WisDOT Bridge Manual

January 2025 Updates

James Luebke, P.E.
Policy and Standards Engineer
February 25th, 2025

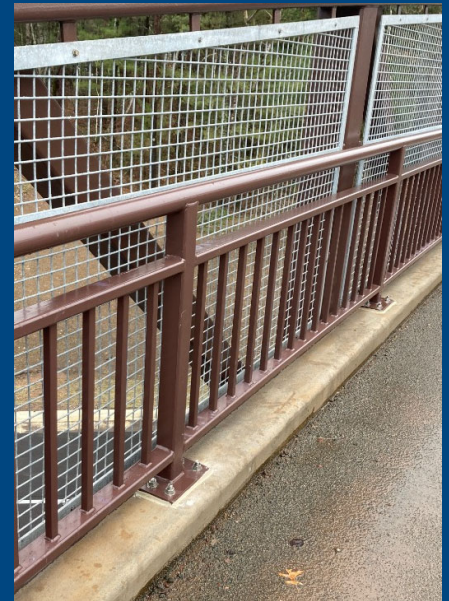
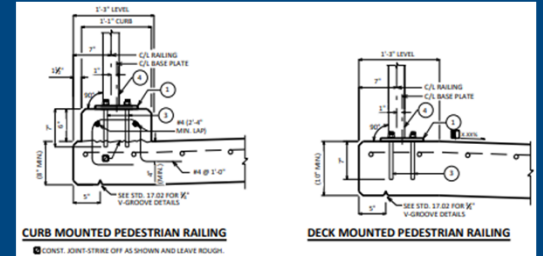
- Standard 30.40 – Pedestrian Railing *New*
 - Anchorage Details:
 - Curb Mounted
 - Deck/Slab Mounted
 - Applicable Anchorage for Railing or Fence Types:
 - Std. 30.17 - Combination Railings Types 'C1-C6' (*shown*)
 - Std. 30.11 – Chain Link Fence (*similar*)
 - Std. 30.15 – Tubular Steel Railing Screening (*similar*)

■ Standard 39.03

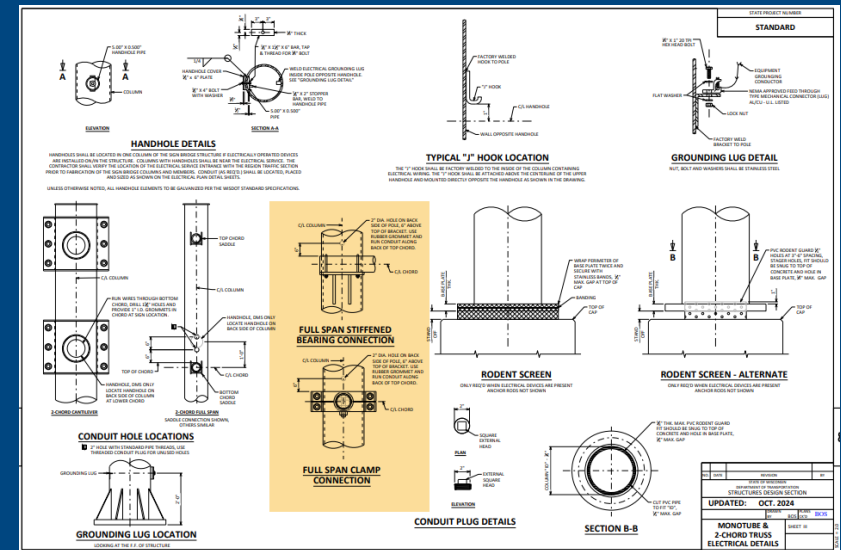
- Full Span Stiffened Bearing Connection
- Full Span Clamp Connection

■ Standard 39.14

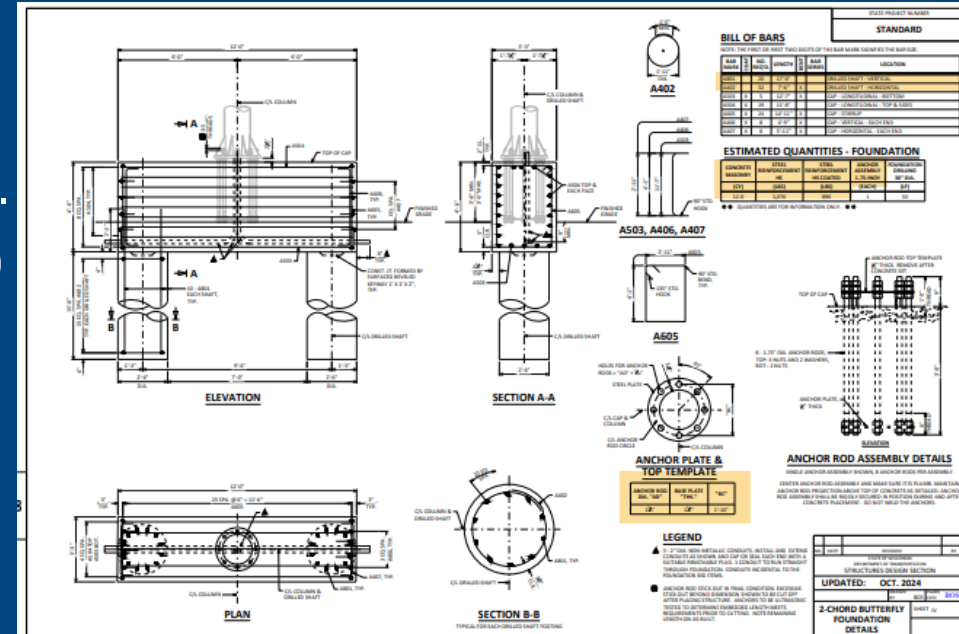
- Updated Bill of Bars
- Corrected Table with 1.75-INCH DIA.
- Updated Quantities (nearest 0.1 CY)
- Added Table for “AD”, “THK”, “BC”

■ Standard 39.37

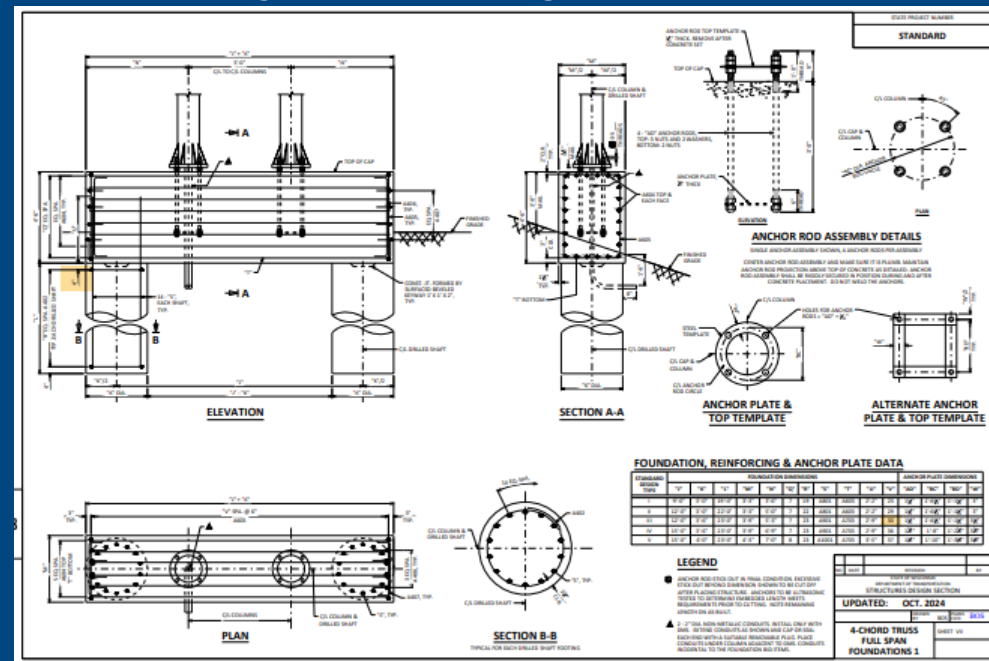
- Added 4" stirrup dimension
- Corrected Type III for "V"

FOUNDATION DATA (PRE-BORING)

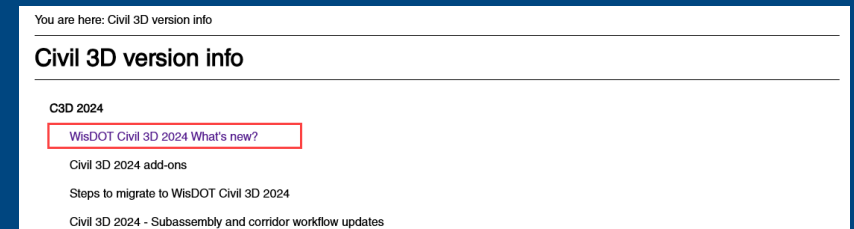
- Chapter 11 - Downdrag Loads
- Updated Blocks (Stay tuned)
